FPL Energy
Seabrook Station

NYN-03049

Seabrook Station
Response to Request for Information
Regarding License Amendment Requests 02-06 and 02-07

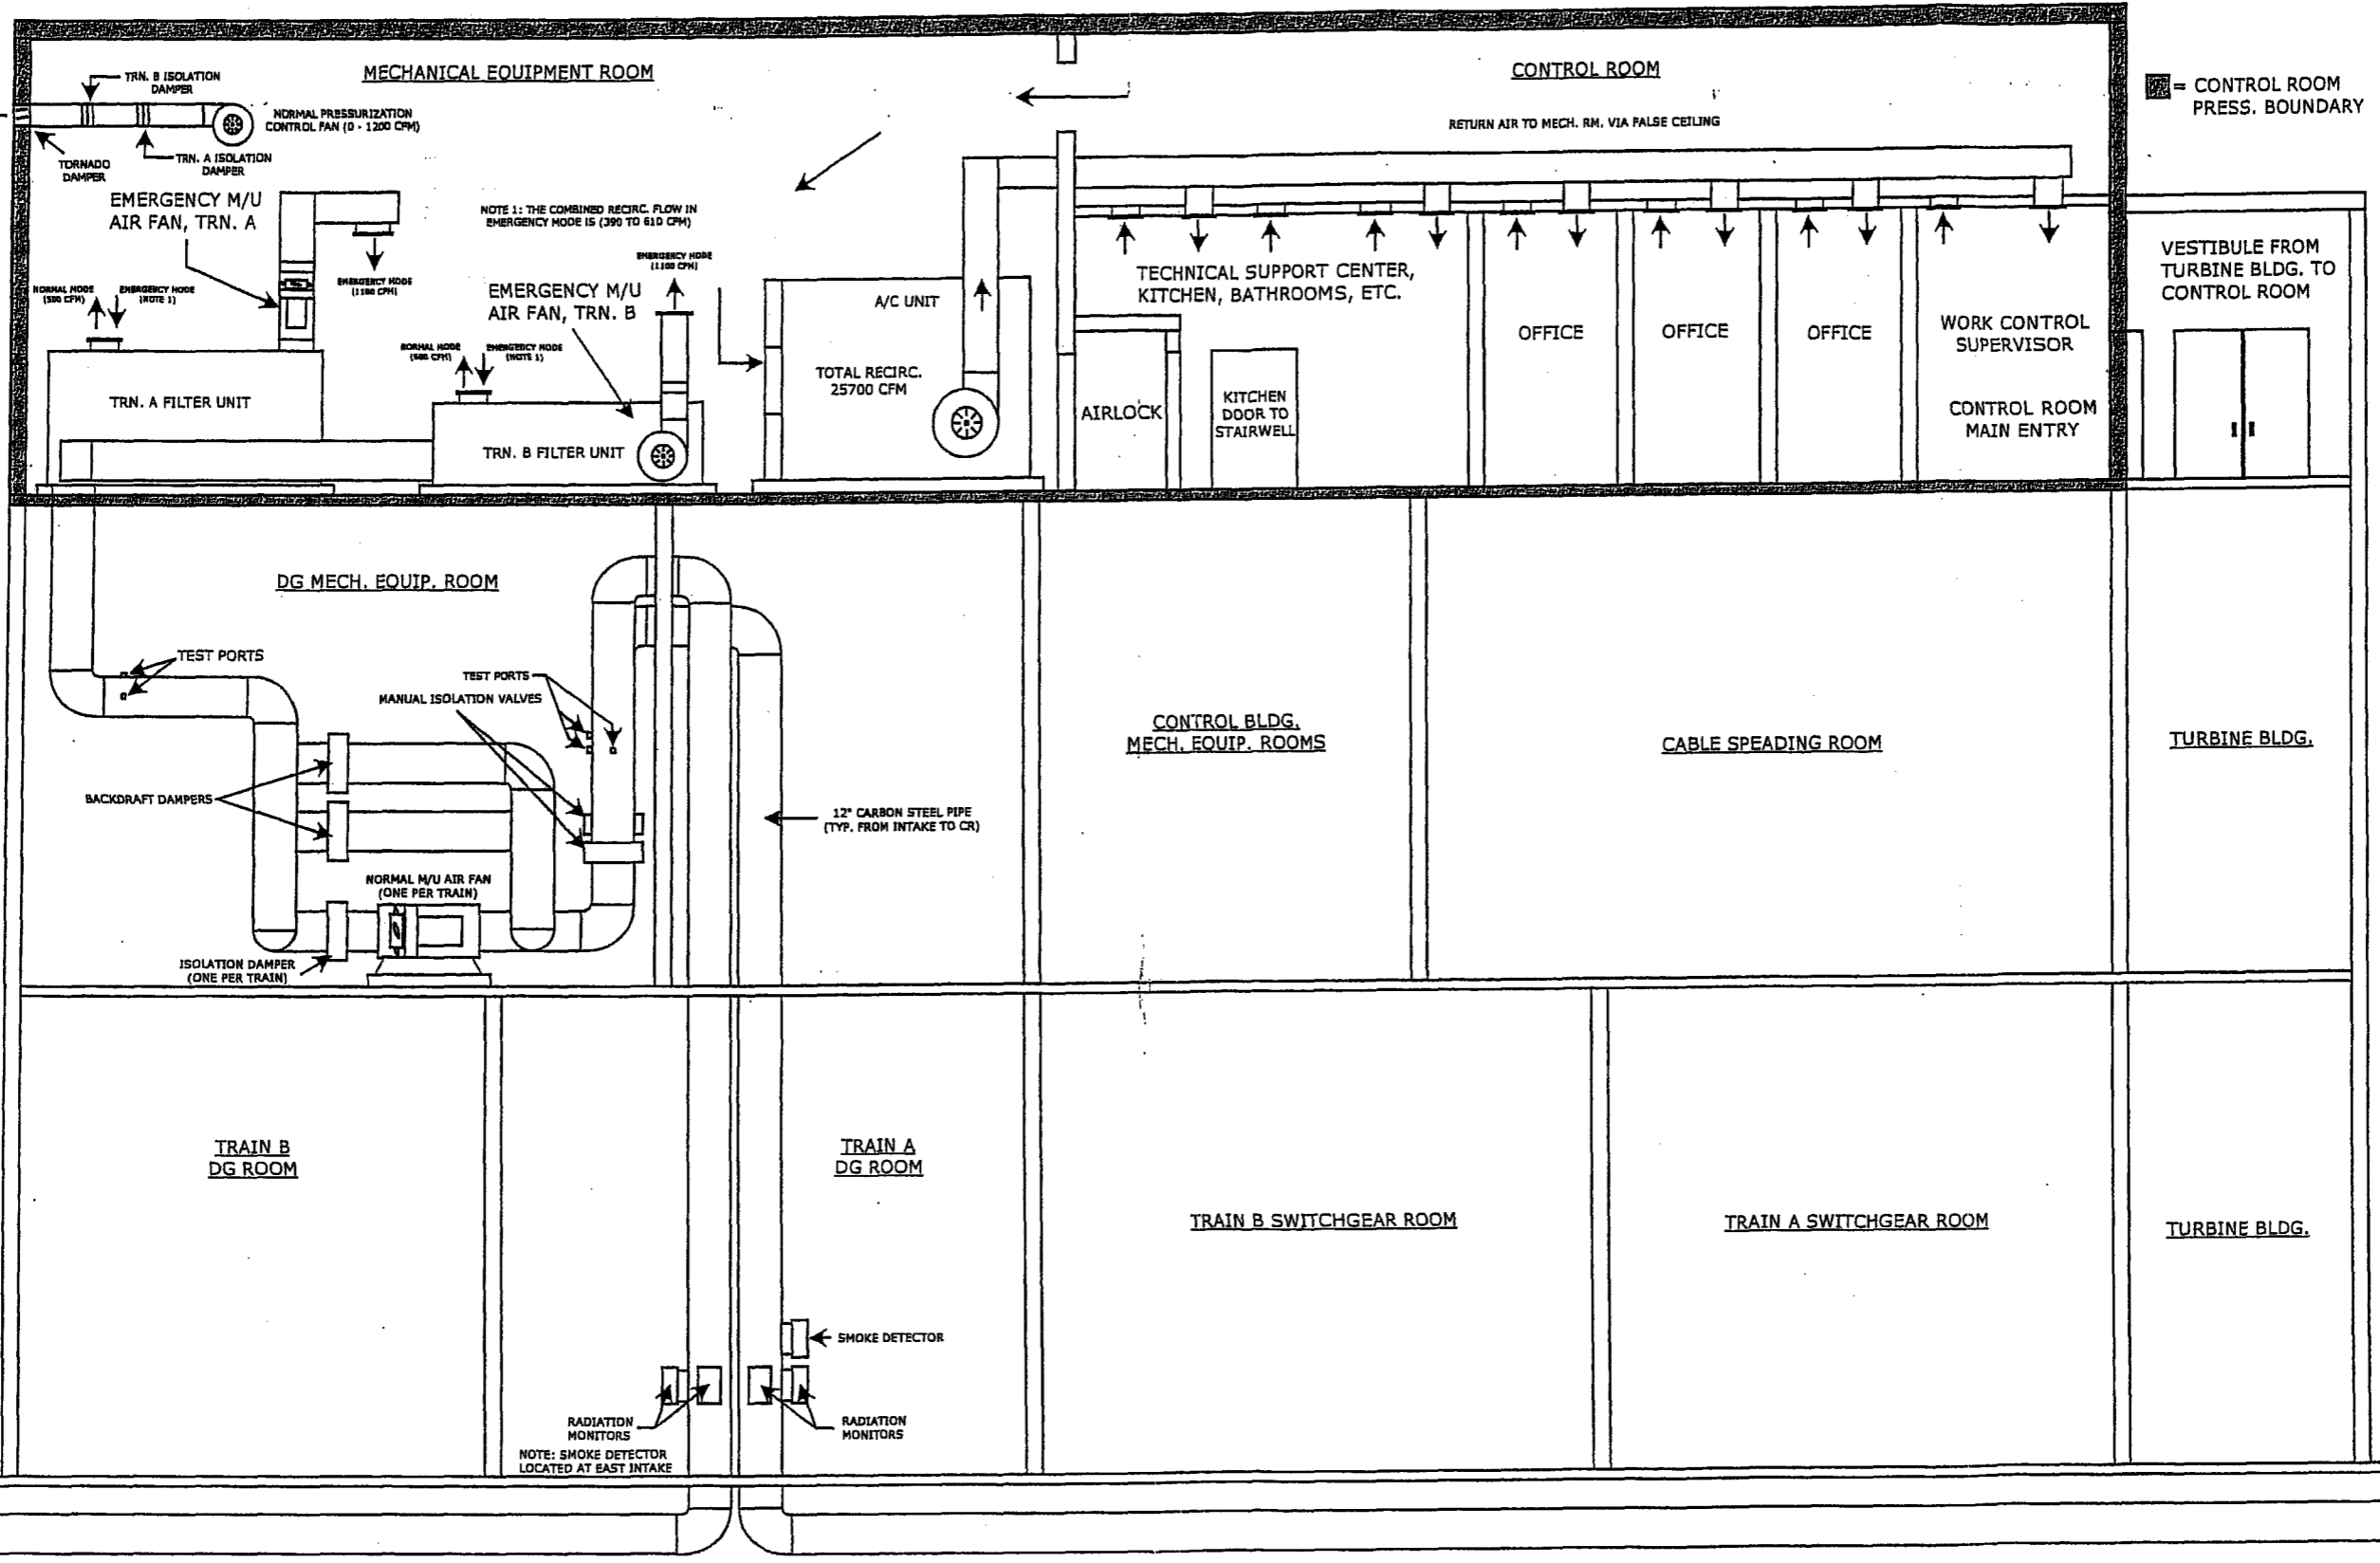
It was requested that a discussion be provided on the operation of the control room filtration process during the fuel handling accident in the open containment.

A drawing of the general ventilation system design and the layout of the associated buildings has been provided as Enclosure 1.
